CITY OF ALBUQUERQUE

Re: Building A & Building B
543 Old Coors Rd. SW
Traffic Circulation Layout
Architect's Stamp 07-21-22 (K11-D027)

Based upon the information provided in your submittal received 08-24-22, the above referenced plan cannot be approved for Building Permit until the following comments are addressed:

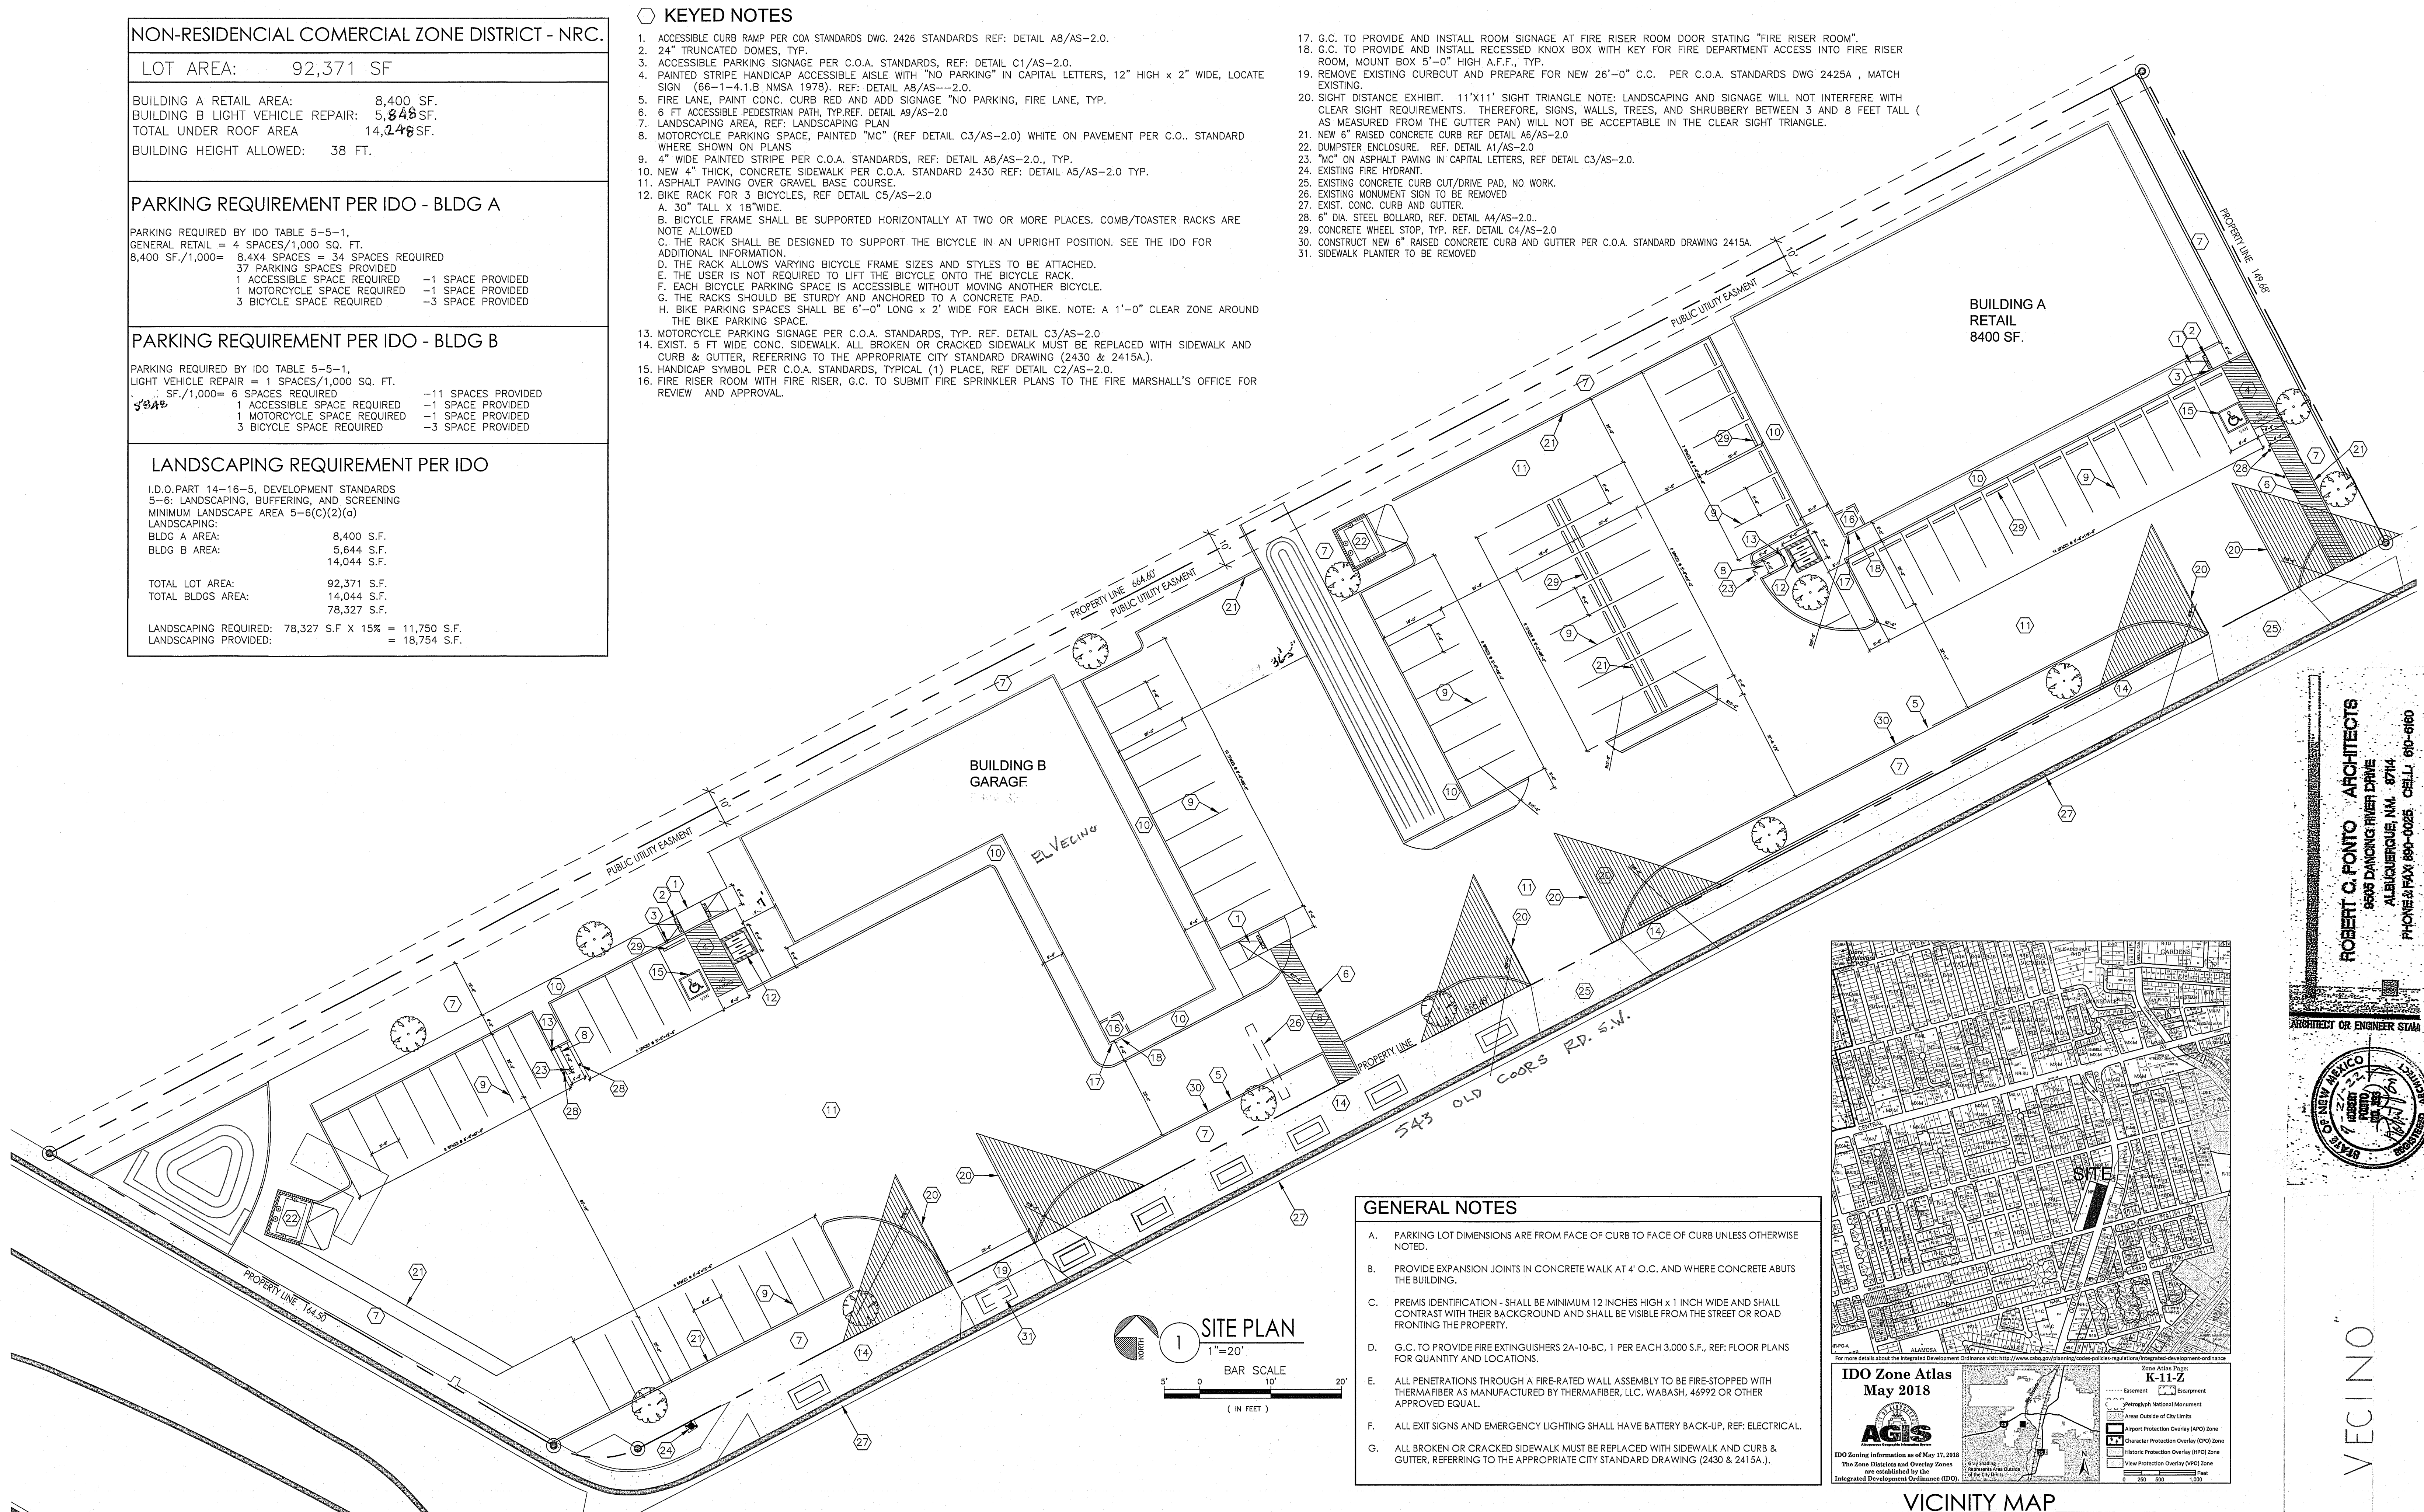
1. Identify the right of way width, medians, curb cuts, and street widths on Old Coors Rd. and on Gonzales Rd.
2. Building A: Per NMBC Table 1106.1, the number of ADA parking spaces required is 2 spaces. Please see attached.

3. Please provide Curb Return design for all Driveways Accesses off Old Coors Rd. SW. and reference COA std dwg 2426.
4. Per the DPM table 3.2-2 the distance from the proposed driveway access to the intersection should 100 ft. Please note that the Old Coors classified as Minor Arterial, and Gonzales Rd classified as Local Street. See attached.

6. ADA curb ramps at the corner of Old Coors Rd. and Gonzales Rd. must be updated to current standards and have truncated domes installed. Please provide details for the existing ADA ramp.

7. Please remove the reference 2426 from key note 1. And add a note "The max. slope for the ADA ramp's landing area is 2% in all directions".
8. A 5 ft. keyway is required for dead-end parking aisles.

9. Provide a copy of Fire Marshall approval.
10. Refuse vehicle maneuvering shall be contained on-site. The refuse vehicle shall not back into the public right of way. provide a copy of refuse approval.

11. Please specify the City Standard Drawing Number when applicable.
12. Unused curb cuts must be replaced with sidewalk and curb & gutter. A build note must be provided referring to the appropriate City Standard drawing.
